NWBPCR Community Meeting #4 Report Out December 7, 2022

Manhattan Community Board 1 Battery Park City Committee

Provide responses to Community Board 1 to inform their resolution related to the Draft Scope of Work before the comment period for the Scoping Document ends on December 31. We will:

REACH 5
North
Cove

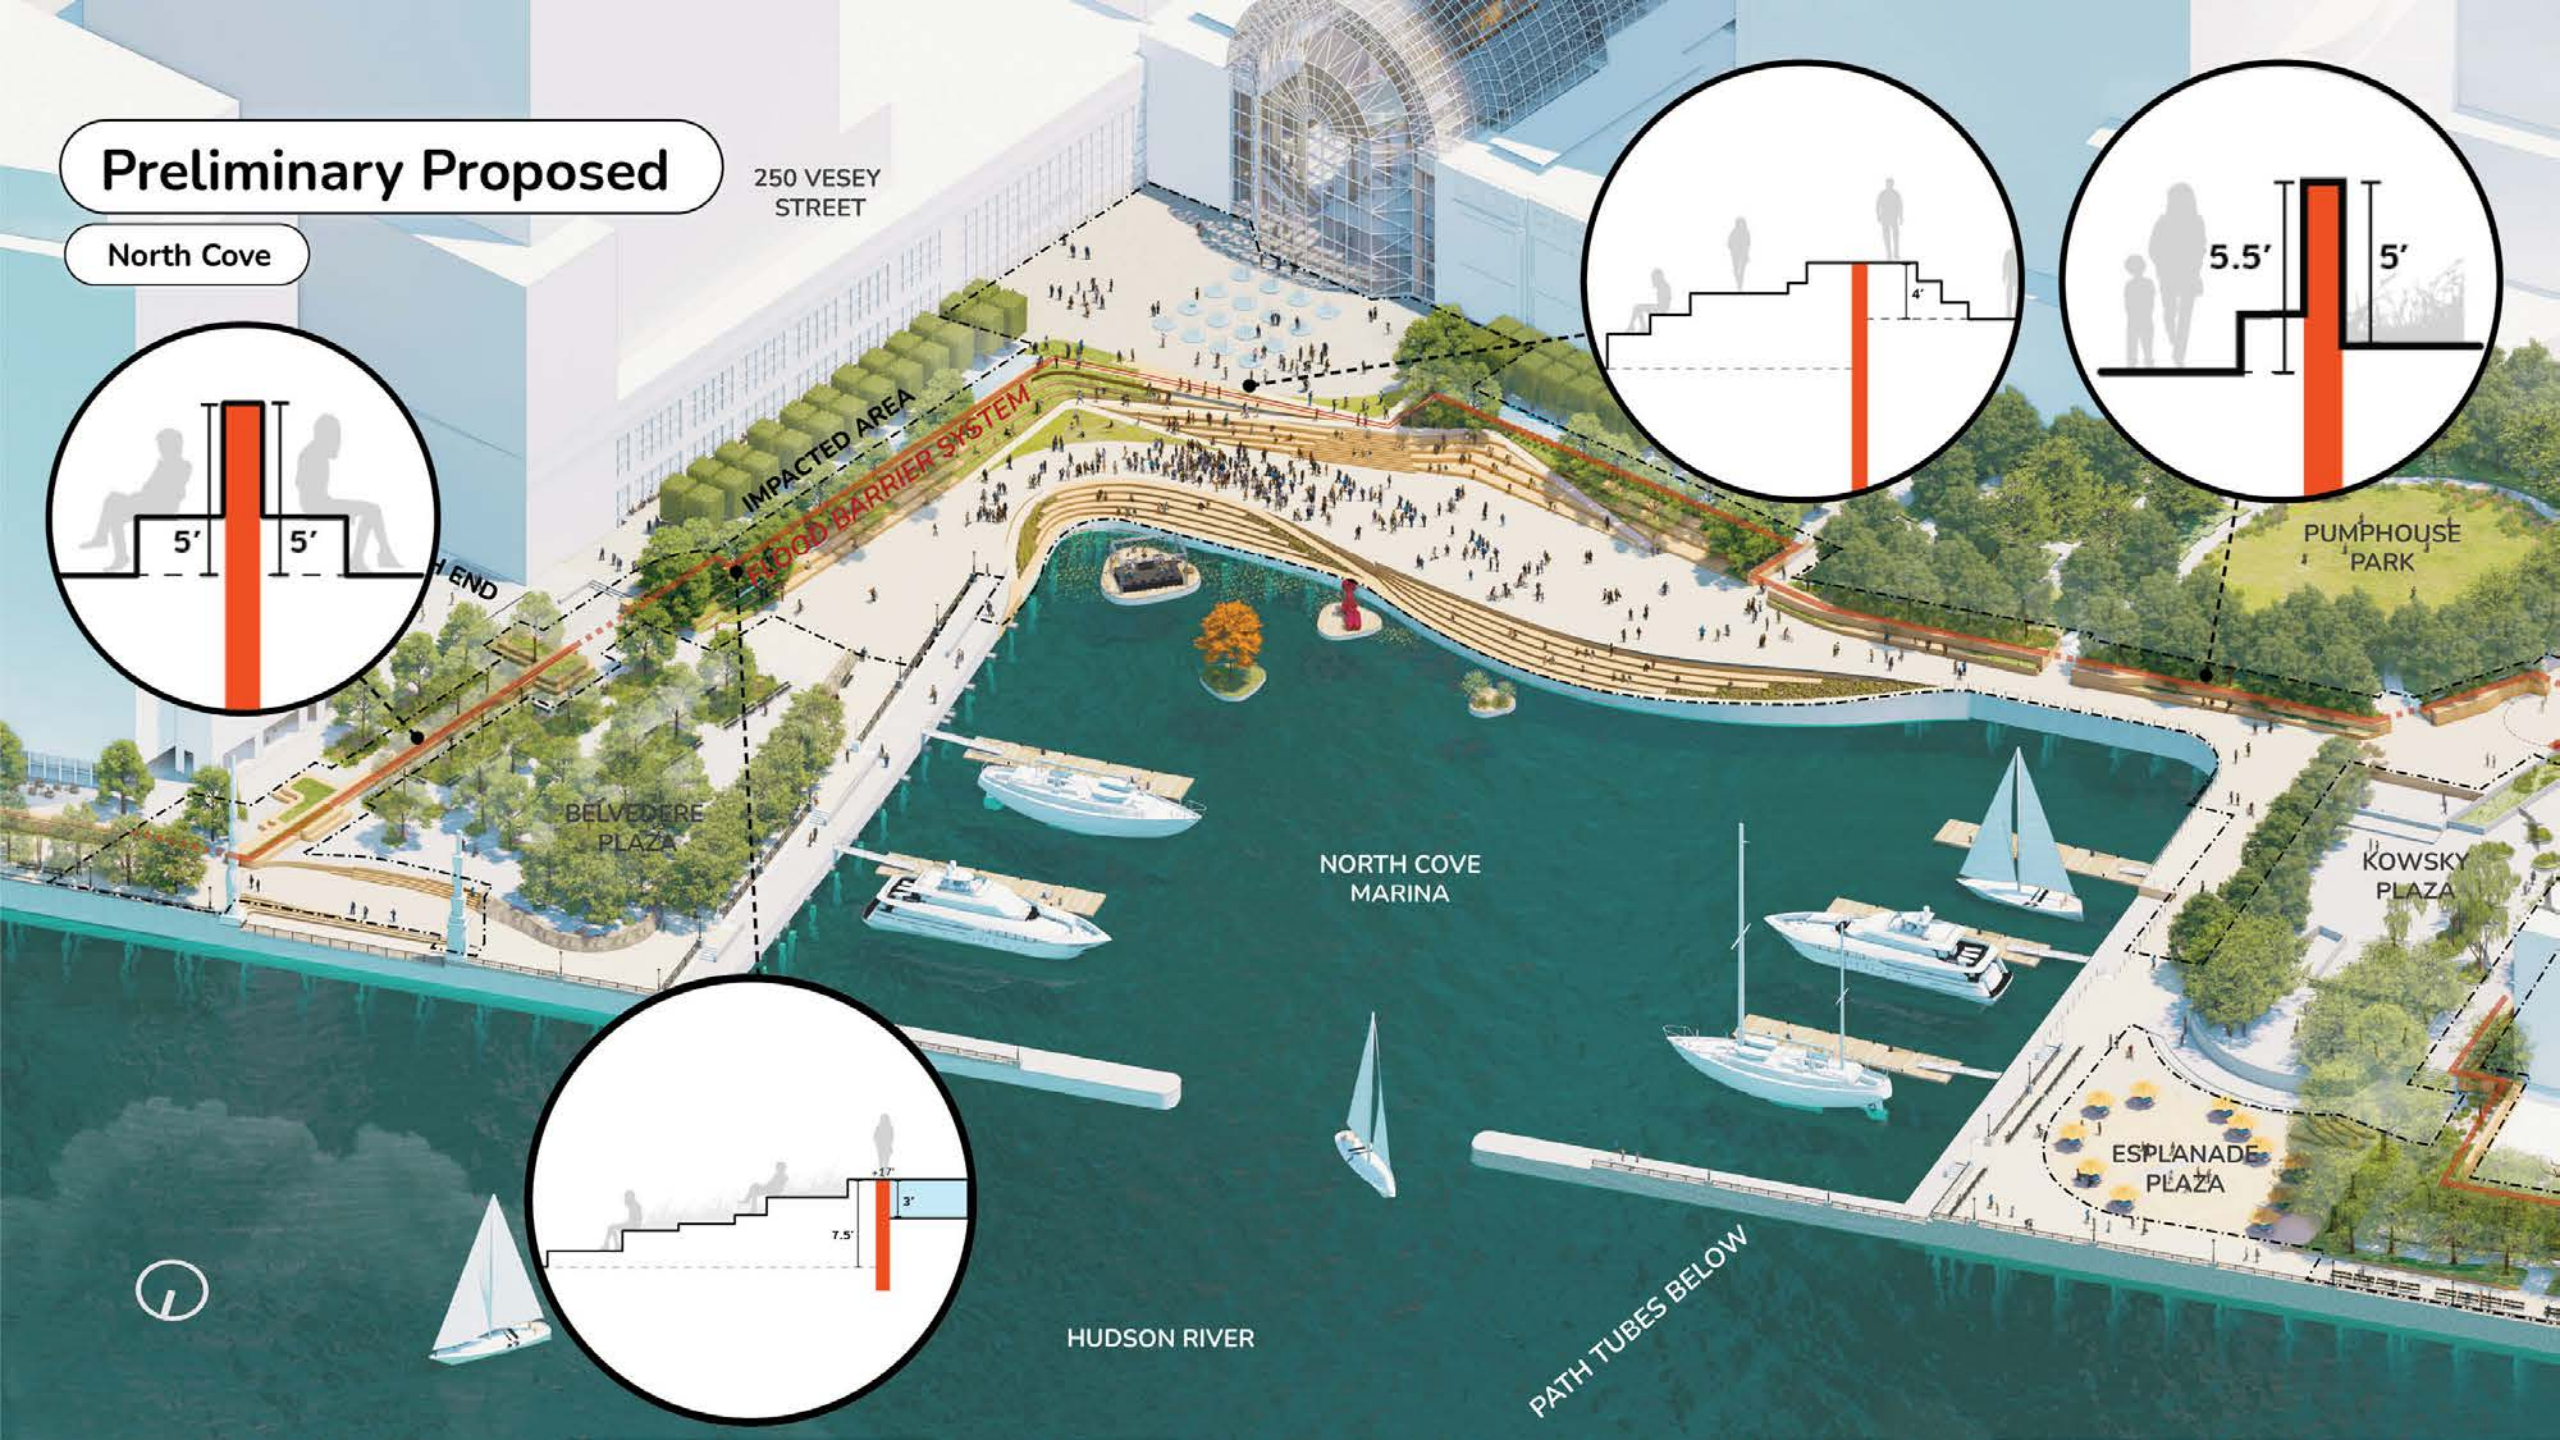
1. Would option 5A obscure the views for diners at Liberty Bistro and PJ Clarkes?
2. Would the sailing club maintain access?
3. Is an outboard alignment (5B) even a legitimate option?
4. How can universal accessibility be improved in North Cove?

- Agree with design team that this option is much preferred to a wall at the outside of the marina.
- The comment in the open house from the crowd was whether this was even really an alternative and that this reach needed a more legitimate alternative. This component of the presentation also elicited community outcry.
